RE: Wilson Trailer Company Number 000058
Notice of Possible Defect

REPORT TO NHTSA

3. Total Number of Vehicles Subject to Recall: 7429 US trailers
4. Percentage of Trailers Estimated to be Defective: 15 trailers .2%
5. Description of Defect: The defect concerns the lock support tube that may have been installed beyond specification. Consequently, the lock could develop inadequate pin engagement with the lock keeper, resulting in the gate opening unexpectedly.

INSPECTION PROCEDURE: OUTSIDE RELEASE

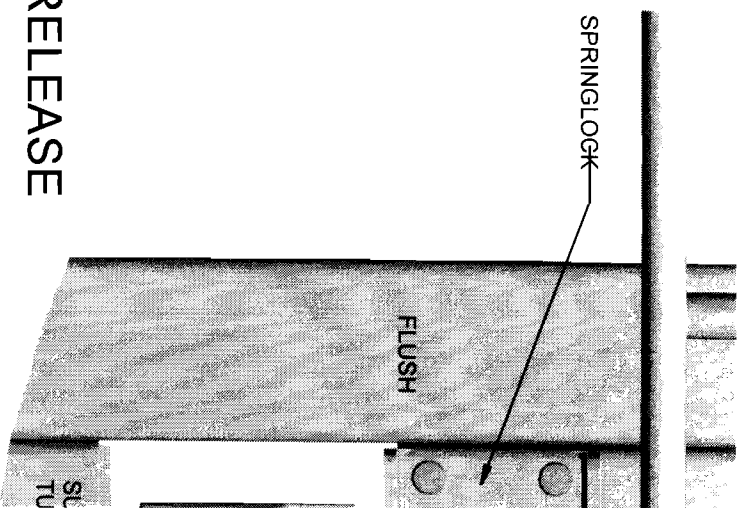
To determine if your trailer has a defect, please check the gap between the keeper and support tube noted as "B" on the attached drawing. If the gap is 3/8 inch or less there is no defect. Please document this on the provided card and send the card back to Wilson Trailer Company. If the gap is greater than 3/8 inch, a field repair is available through Wilson Trailer Company to adjust the support tube to the correct dimension. Please contact Todd Heitman or Linda Kollbaum at 1-800-798-2002 for repair parts and instructions.

6. History of Events: At least two trailers and possibly up to five additional trailers within said timeframe have experienced the described defect.
7. Description of Remedy: Check gate latches for correct dimension between gate latch and support tube, 3/8" maximum. A field repair to install an angle on the support tube to obtain the correct dimension will be provided.

- A. CLOSE THE GATE.
- B. MEASURE GAP B UNDER THE KEEPER.
- C. IF GAP B IS GREATER THAN 3/8", CONTACT WILSON TRAILER COMPANY WARRANTY FOR REPAIR PARTS.
- D. IF GAP B IS 3/8" OR LESS PLEASE FILL OUT THE SUPPLIED CARD & RETURN TO WILSON TRAILER COMPANY.
